# **OTWAY WATER BOOK 50 <sub>B</sub>**

**Remediation and Section 78 Notice  
Documents.  
2018-2019.**

**Feedback on Barwon Water Section 78 Scope of Works submission**

Boundary Creek, Big Swamp and Surrounding Environment – Remediation and Environmental Protection Plan. Scope of Works. Barwon Water, 20<sup>th</sup> December 2018.

Figure 9-6 : Predicted watertable drawdown in 2010

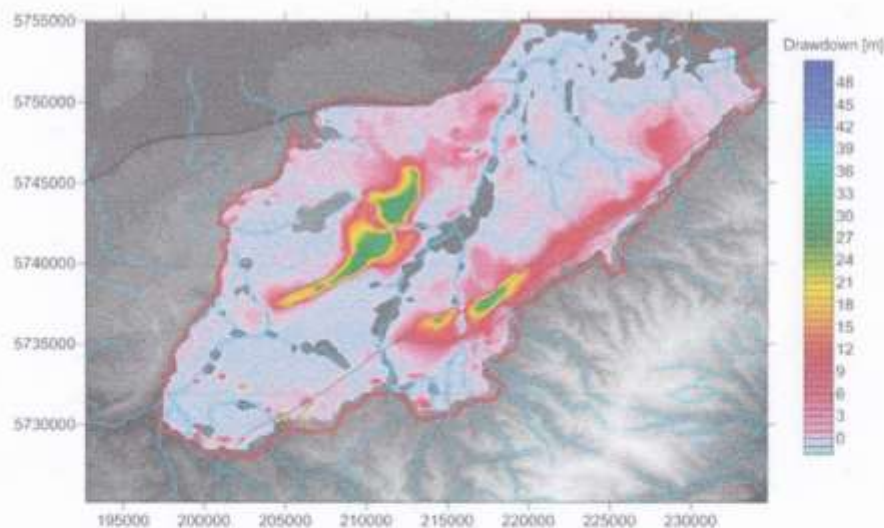
The main issue here is that Figure 9.6 in the Jacobs report (below) shows that the modelled watertable drawdown in 2010 under the operation of the borefield, includes areas outside of the immediate environs of Boundary Creek and Big Swamp.

When comparing the predicted change in watertable to the information on potential groundwater dependent ecosystems (for example, those illustrated in the Bureau of Meteorology Groundwater Dependent Ecosystem Atlas – refer to appendix A) there are potentially far more widespread environmental impacts from the operation of the Barwon Downs borefield than in the immediate environs of Boundary Creek and the Big Swamp.

For example, the above figure also identifies areas on the southern side of the Barwon Downs Graben, where the Lower Tertiary Aquifer (LTA) outcrops near the Barwon River East and West branches, that are affected by groundwater level drawdown to a similar degree as near the Boundary Creek and Big Swamp. Furthermore, and contrary to statements in the Scope of Works (section 5.1), the groundwater model does not over-predict drawdown in the Barwon River area (e.g. the first figure in Appendix D of the cited technical report by Jacobs (2017) shows sound model predictions at monitoring bores 64241, 48249 and 82845).

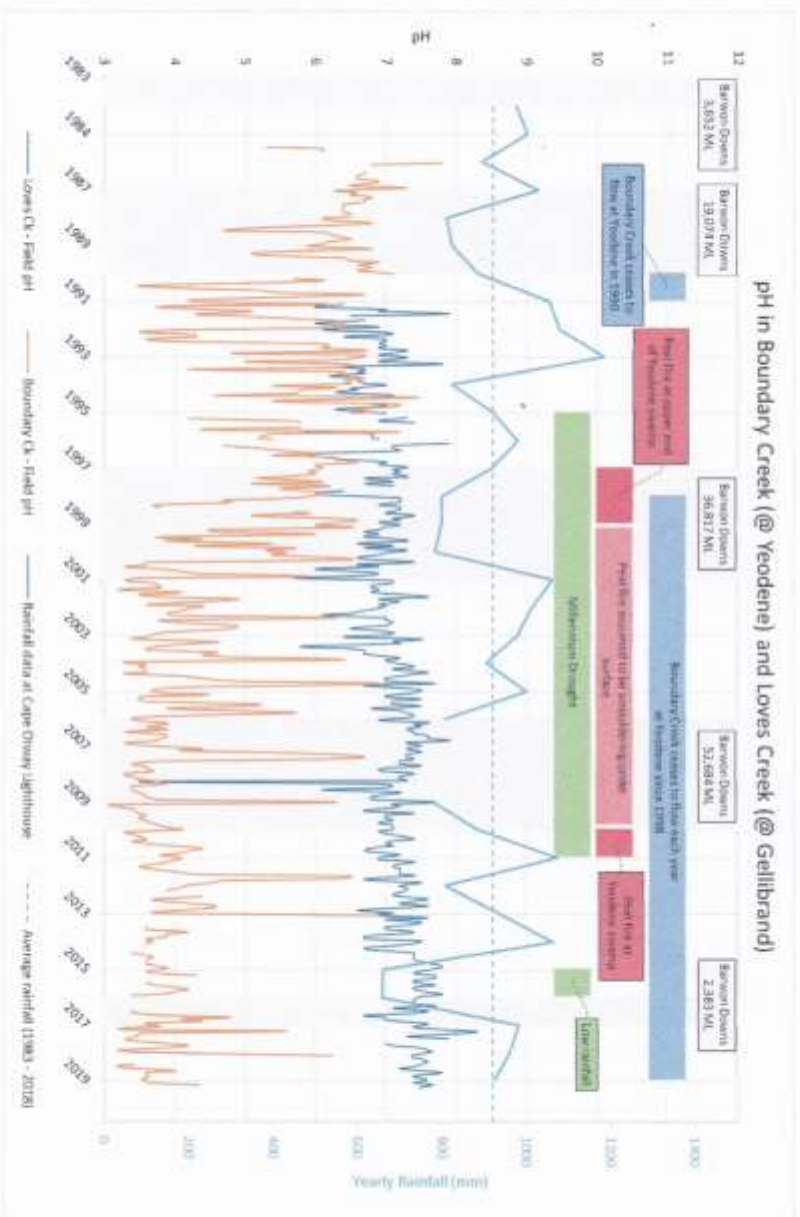
- Significant decreases in the pH of Boundary Creek commenced shortly after detailed field-based monitoring began;
- pH values in Boundary Creek fell to as low as 4.8 during the period from 1987-1990, when groundwater extraction resulted in groundwater levels falling below the bed level of Boundary Creek at Reach 2 for the first time (Figure 3);
